In the matter of Proposed Plan Change G to the Operative District Plan for  
Palmerston North

**Statement of evidence of Glenn Connelly for Waka Kotahi New  
Zealand Transport Agency Limited -Transport**

Dated 27 October 2023

**Figure 7: Collision Speed & Risk of Pedestrian Death or Serious Injury<sup>4</sup>**

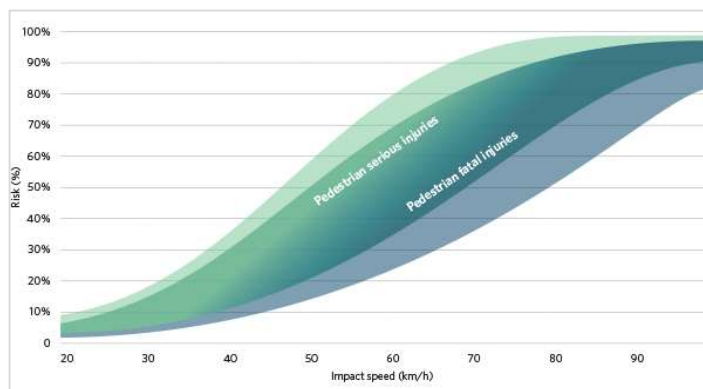
1. The main crash risk along the highway is speed, as it presents the greatest risk of death or serious injury. The existing 70 kph speed limit places all road users at risk with an elevated risk of injury for car drivers with side impact crashes<sup>7</sup>, and for all crashes involving vulnerable road users<sup>8</sup>.

2. The speed limit will be reviewed in the 2024-27 State Highway Speed Management Plan. 70kph speed zones are being reviewed as a priority as their use is being phased out. The increasingly urban development in the PPCG area would see the speed limit reduce to 60 or 50kph. This will improve safety in many ways; by providing more reaction and observation time and greater recovery time. It is also likely to achieve side impact speeds of 50 kph or less and which would align with safe system outcomes of having a low risk of death or serious injury.

**Figure 13 Strava Heatmaps**

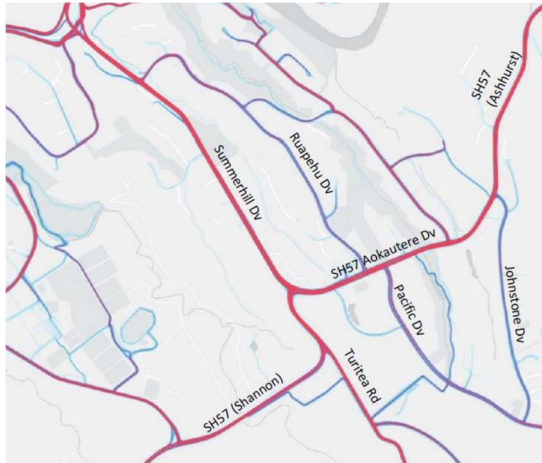
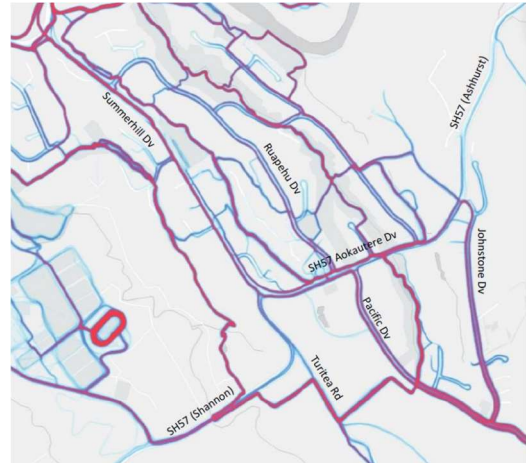
11. There is pedestrian and cycling activity in and around the SH57 / Turitea Road intersection which is likely to increase with additional development in the Turitea Road catchment as proposed under PPCG.
12. A lower speed limit in this area would improve safety and may be better suited to the recreational and potentially increasing number of pedestrians and cyclists. The speed, design and improvements should thus be considered in holistic review of the route, including provisions for walking and cycling.

**Figure 15: Transport Choices Separated Cycle Ways – Aokautere**

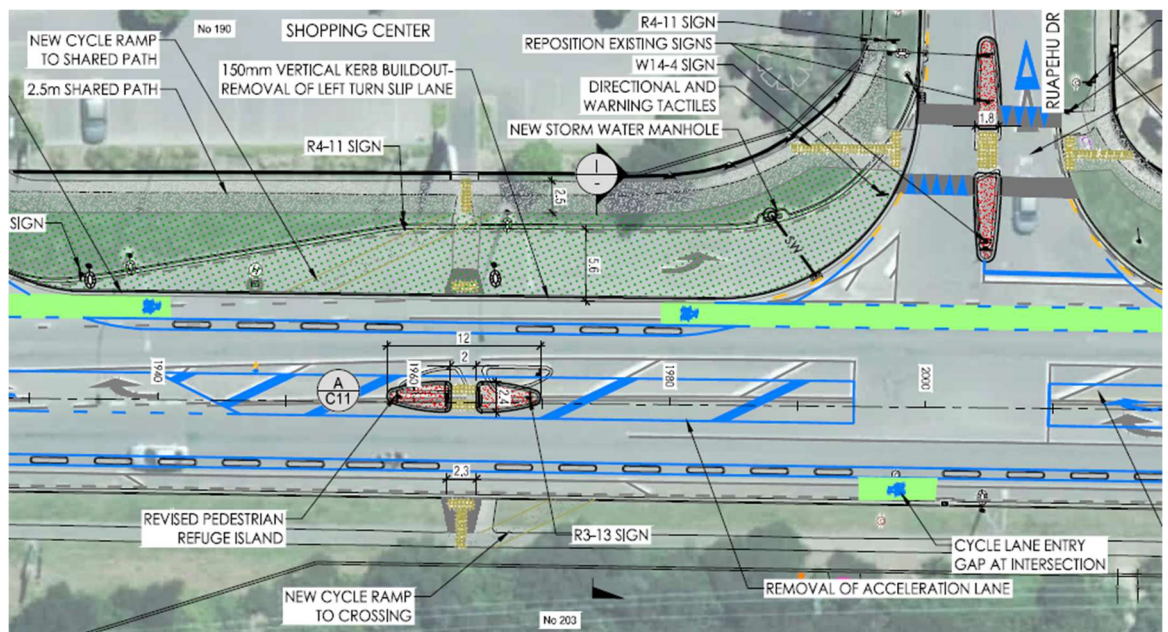
20. The traffic volumes, width of the road and speed present a challenge and safety risk for pedestrians wanting to cross the highway. This is referred to as severance. There is only one crossing facility located in front of the Summerhill Shopping Complex. It is in the form of a centre refuge island, has higher motorist speeds, and longer crossing distances over multiple lanes.
21. A Transport Choices project has been approved with the detailed design well progressed for the installation of separated cycleways along the SH. This will see improvements made to the existing crossing point. The lowering of the speed limit with a broader review of pedestrian safety and provisions should address safety concerns.
